Sunland-Tujunga Neighborhood Council

RE: The Verdugo Hills Golf Course Project - RP-DEIR
6433 La Tuna Canyon Road Project
Case No. ENV-2007-3083 - EIR
SCH No. 2007121012

Diagrams from the Guidelines that depict this intended use of the regulations include the following:

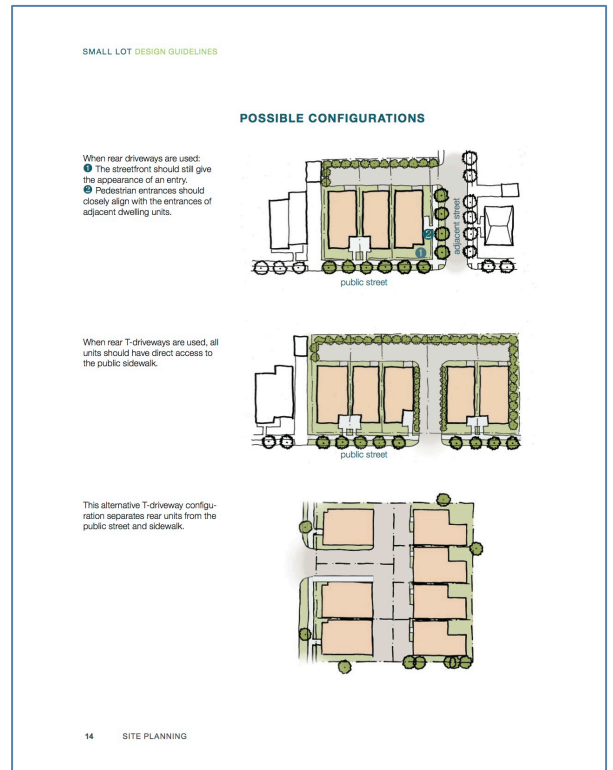
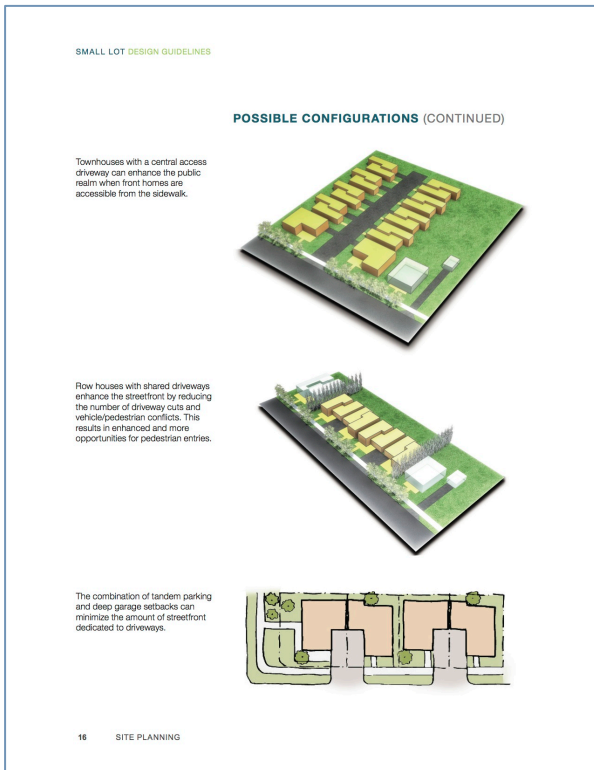
- This project alternative violates **Intent** of Small Lot Ordinance. The Small Lot Ordinance was intended as an innovative housing tool to encourage the development of alternative fee- simple homeownership in areas *zoned* for multi-family and commercial uses. The Ordinance creates incentives for *infill*

residential development to spur more housing production. As such, it was never intended to be used as a tool to promote dense housing on properties similar to the VHGC. The City's Small Lot Design Guidelines clearly depict the intended use of the ordinance, namely to allow owner-occupied infill housing to be constructed on narrow lots in already developed neighborhoods.

As depicted above, the intent of the ordinance was to encourage infill residential development (fee-simple home ownership) on existing City streets with properties having access from those streets and from public alleys, if available. The proposed project does not comply with these guidelines. It perverts the intent of the ordinance by using its provisions to create fee-simple home ownership small lots in a clustered housing project that is highly dense and inappropriate for the proposed location.
